Access Compliance Report Public Rights-of-Way (RR Crossings)

Intersection ID: 7486	Main Street: N_TRYON_ST	Location: N/A
ADA ID: 34DEA5099F73	Overall Compliance: No	Severity Score: 0.0
Codes/Mitigation Info/Possible Solution		Field Measurements/Component Compliance

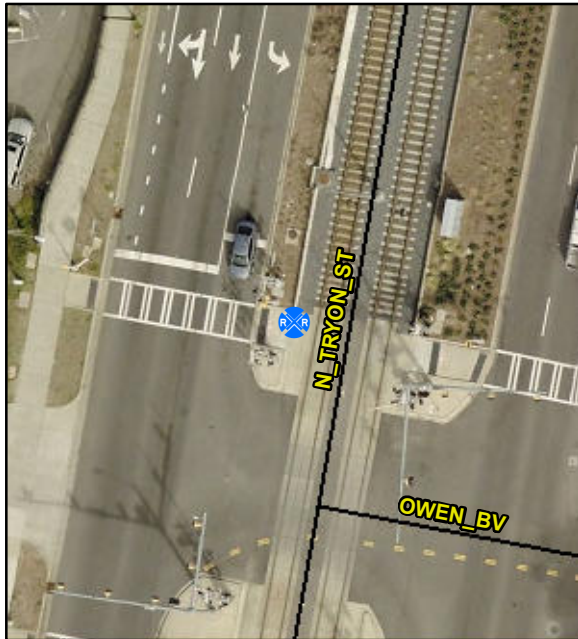
Remove & Replace Detectable Warning System. Provide Pedestrian Gate. Remove & Replace Walking Surface Adjacent to Rail.

R302.7.4, R305.2.5

Compliance	Description	Data
Yes	DWS Provided?	Yes
Yes	DWS Contrast?	Yes
Yes	DWS Width (in)	Yes
Yes	DWS Length (in)	24.0
Yes	DWS Offset (in)	151.0
No	Pedestrian Gate?	No
N/A	DWS Outside Gate?	No
N/A	Rail Type?	LightRail
No	Flangeway Gap (in)	29.0
Yes	Sidewalk Width (in)	121.0
